**Amendments to the Drawings:**

Serial No.: 10/648,012  
Amdt. Dated: February 10, 2006  
Reply to Office Action of December 30, 2005

Attorney Docket No.: 73785-013

Figure 2

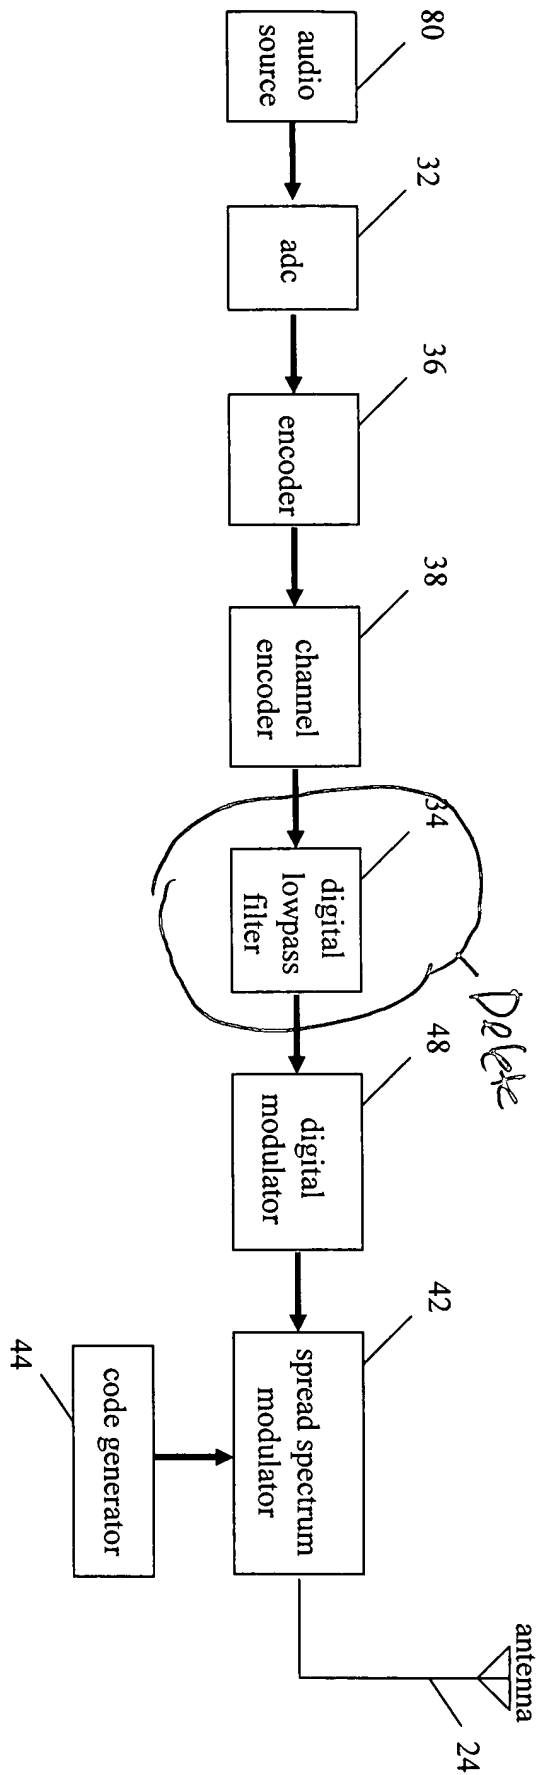
The drawings were objected to as incorporating new matter because of the altered order of the filter in relation to other elements. Corrected drawings were required because of the altered order of the filter in Figs. 2 and 3. More particularly, with respect to Fig. 2, the low pass filter was shown between the ADC and encoder, thus differing from the drawings in the parent application. With respect to Fig. 3, the bandpass filter was shown in a different order from that shown in the parent.

In order to expedite matters, Applicant has deleted the low pass filter of Fig. 2 as well as the bandpass filter of Fig. 3. These filters are often included with analog-to-digital converters and demodulators such as those shown in Figs. 2 and 3.
